ITEM: 6.7	REPORT SUMMARY MINOR VARIANCE APPLICATION FILE NUMBER A066/25
-----------	---

## MINOR VARIANCE APPLICATION FILE NUMBER A066/25

<b>CITY WARD #:</b>	1
<b>APPLICANT:</b>	Rahul & Shikha Goel
<b>AGENT:</b>	Andrew Solari (Bancheri Bros. Interlock Paving Corp.)
<b>PROPERTY:</b>	321 Woodgate Pine Drive, Kleinburg
<b>ZONING DESIGNATION:</b>	See Below
<b>VAUGHAN OFFICIAL PLAN (2010) DESIGNATION:</b>	Vaughan Official Plan 2010 ('VOP 2010'): "Low Rise Residential"
<b>RELATED DEVELOPMENT APPLICATIONS:</b>	N/A
<b>PURPOSE OF APPLICATION:</b>	Relief from the Zoning By-law is being requested to permit a proposed cabana in the rear yard.

**321 WOODGATE PINES DRIVE**  
**ACCESSORY STRUCTURE**  
**Vaughan, Ontario**

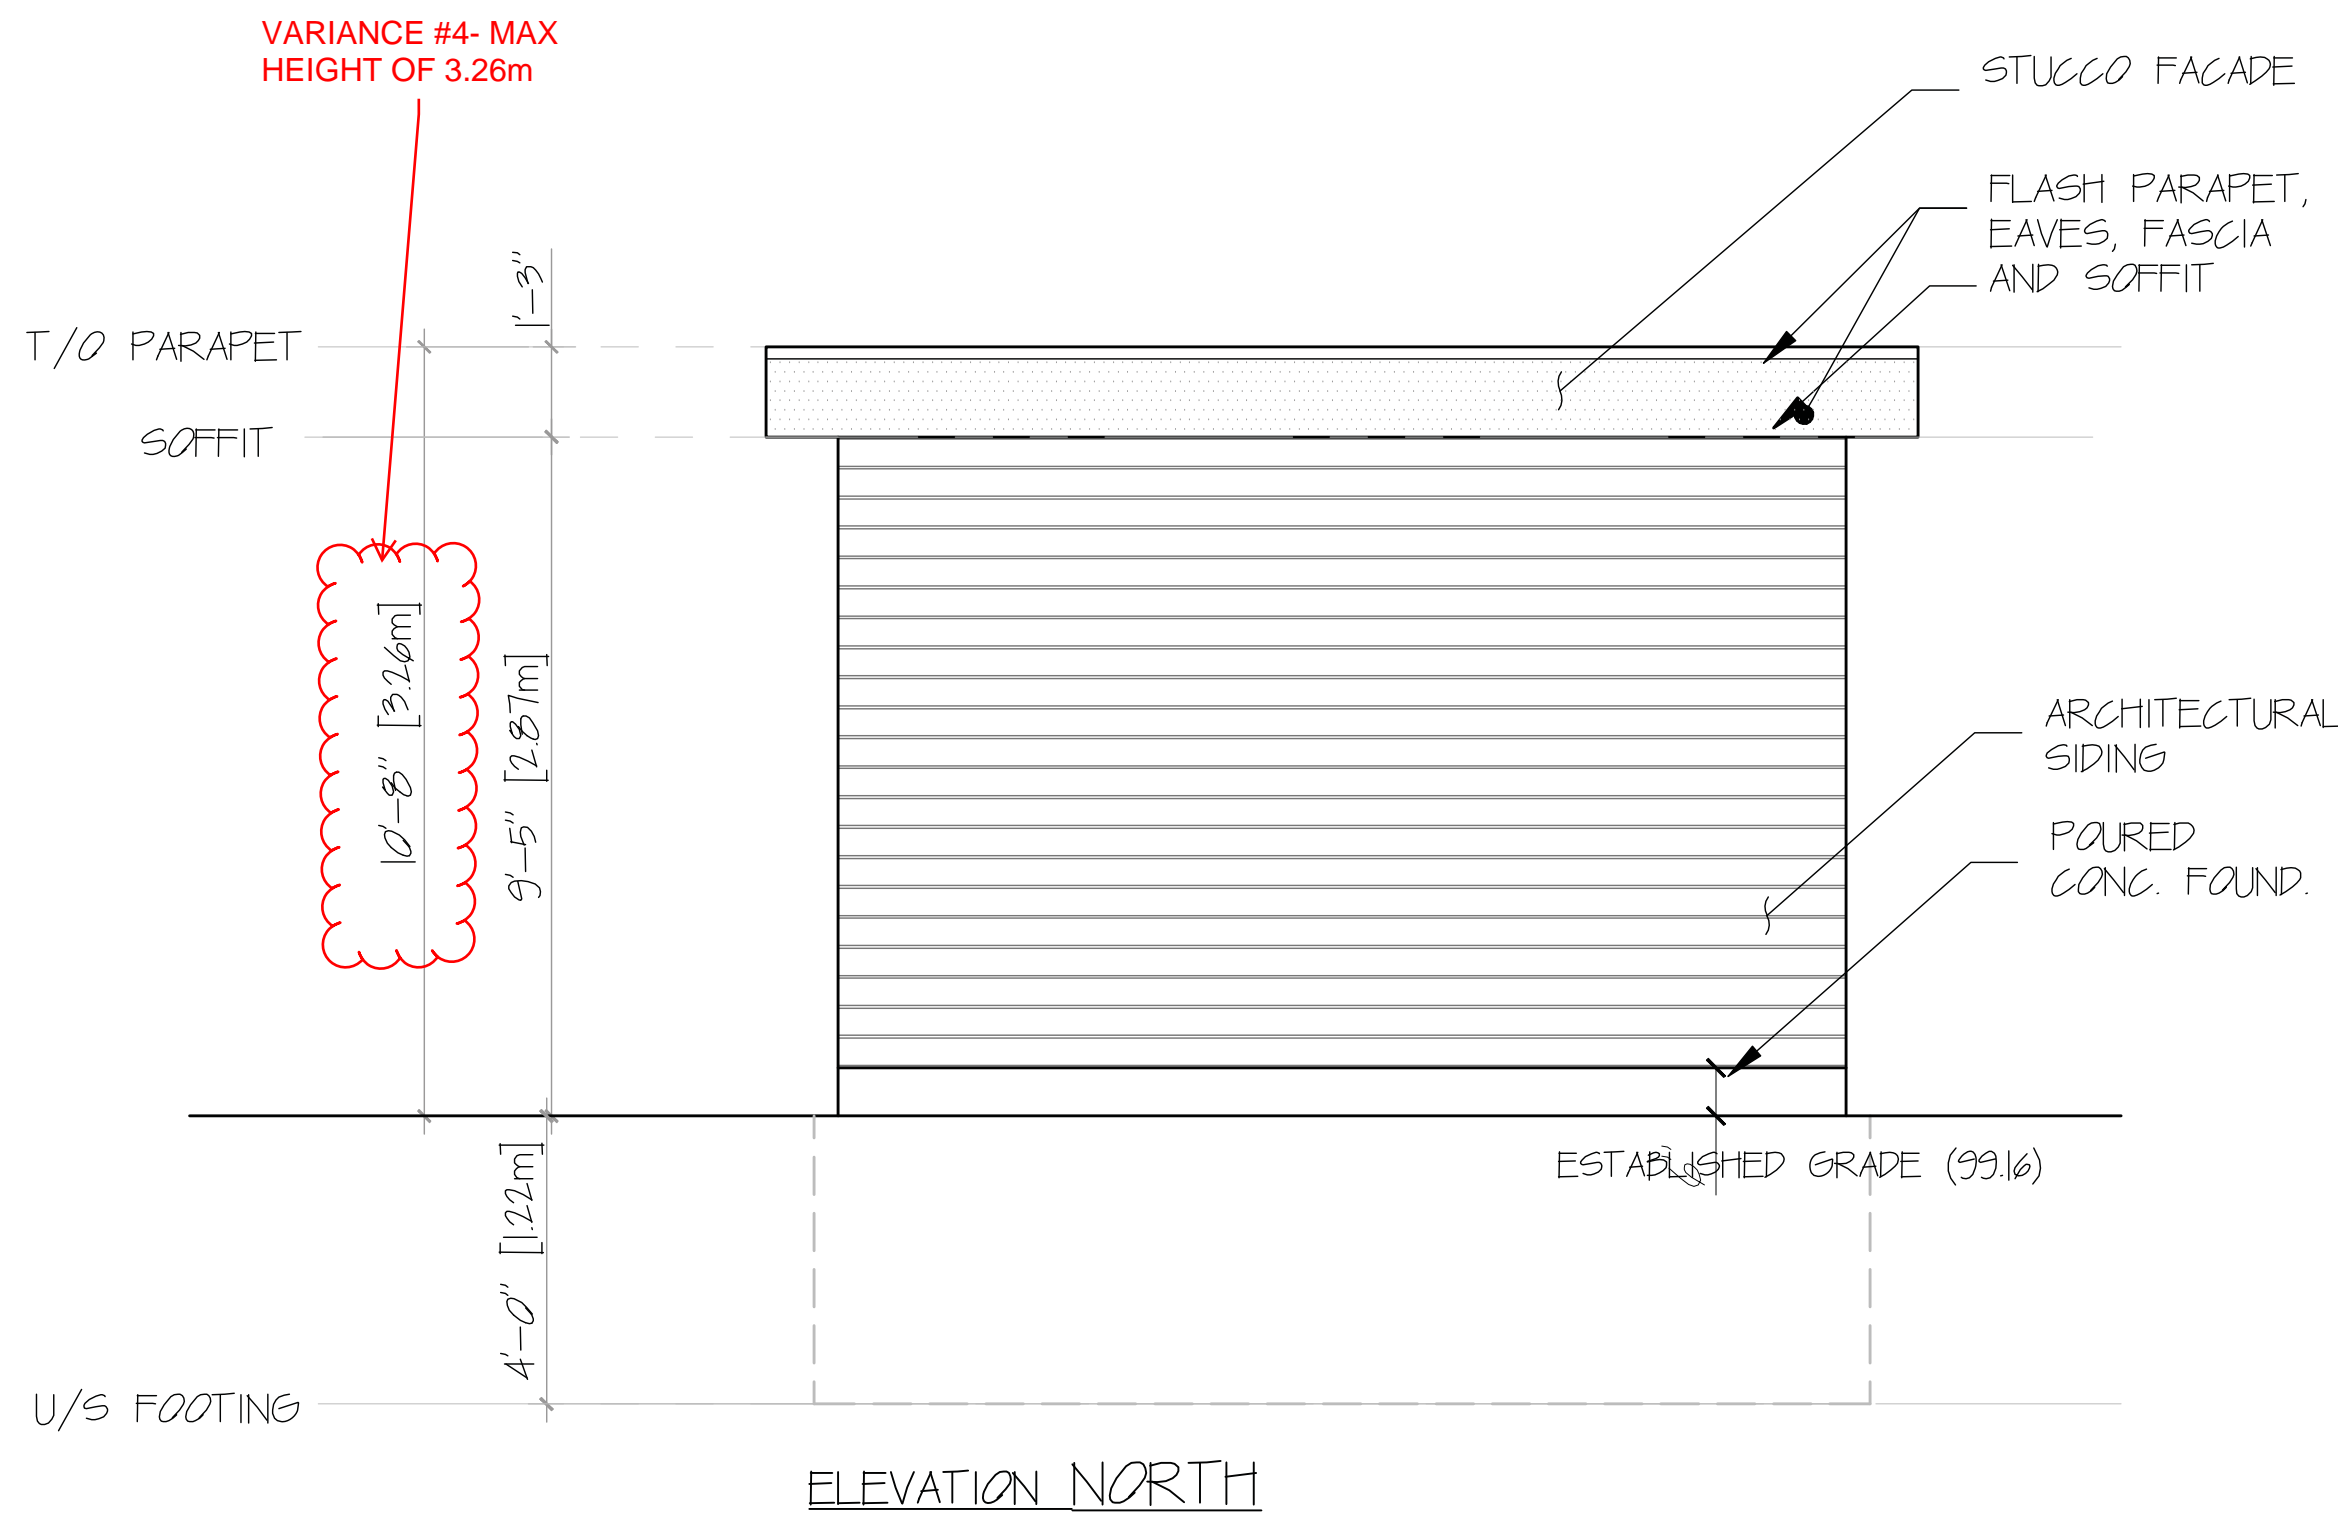
The Development and Parks Planning Department has no objections to Variance 4 to permit an increased height of the proposed cabana from 3.0 m to 3.26 m. The majority of the cabana is unenclosed, which minimizes massing impacts on neighbouring properties. The proposed cabana is compliant with lot coverage and is not anticipated to incur any negative impacts on the neighbouring properties.
